Appl. No. 10/016,132
Response dated February 17, 2005
Reply to Office Action mailed November 17, 2004

REMARKS

FIG. 1a

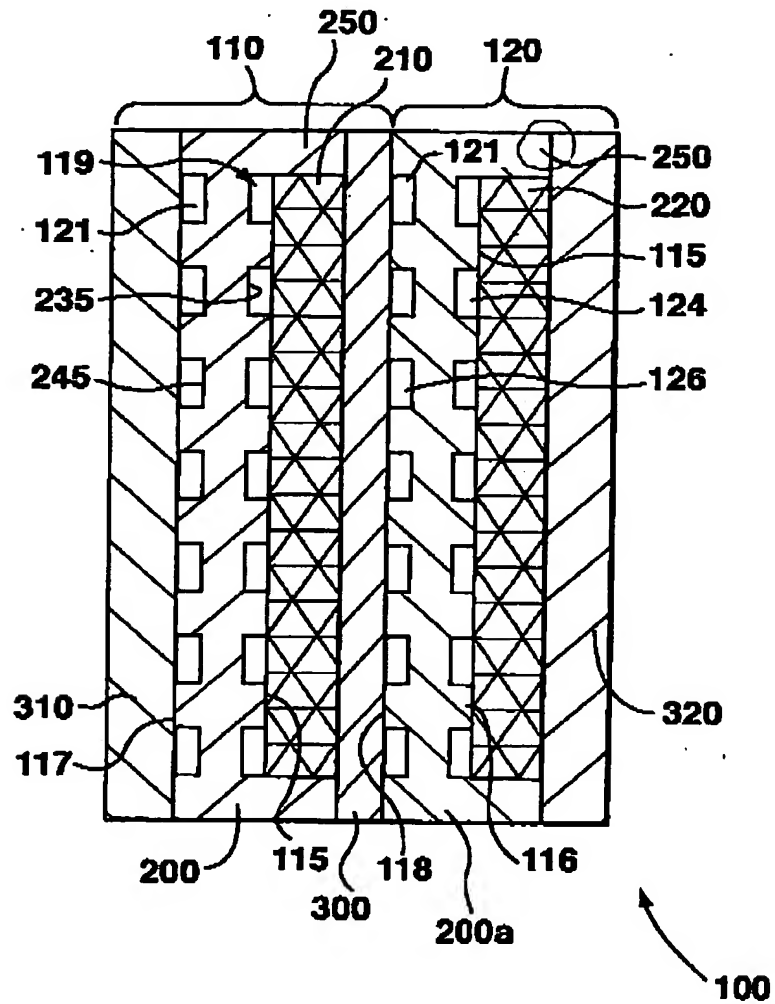
As requested by the Examiner, an amended Figure 1a is attached, showing a proposed correction to the lead line for one of the reference numerals 250, to ensure that this reference is used consistently.

Significantly, it is also now provided that there is a "rim" that is "provided around and partially defining the reaction chamber". As the Examiner noted in his comments on the drawings, reference 250 identifies a rim around each reaction chamber. Accordingly, no new matter has been added. With respect to the gasket grooves, these are now more clearly defined in a new, final paragraph of claim 1. Here, it is specified that the gasket grooves are provided between the reactor and separator plates, with one gasket groove being provided in the rim around each reaction chamber. Then, it is specified that gaskets are provided in the gasket grooves between adjacent pairs of reactor and separator plates.

The attached sheet of drawings contains changes to Figure 1a. That sheet, which contains a drawing of Figure 1a, replaces the original sheet containing Figure 1a.
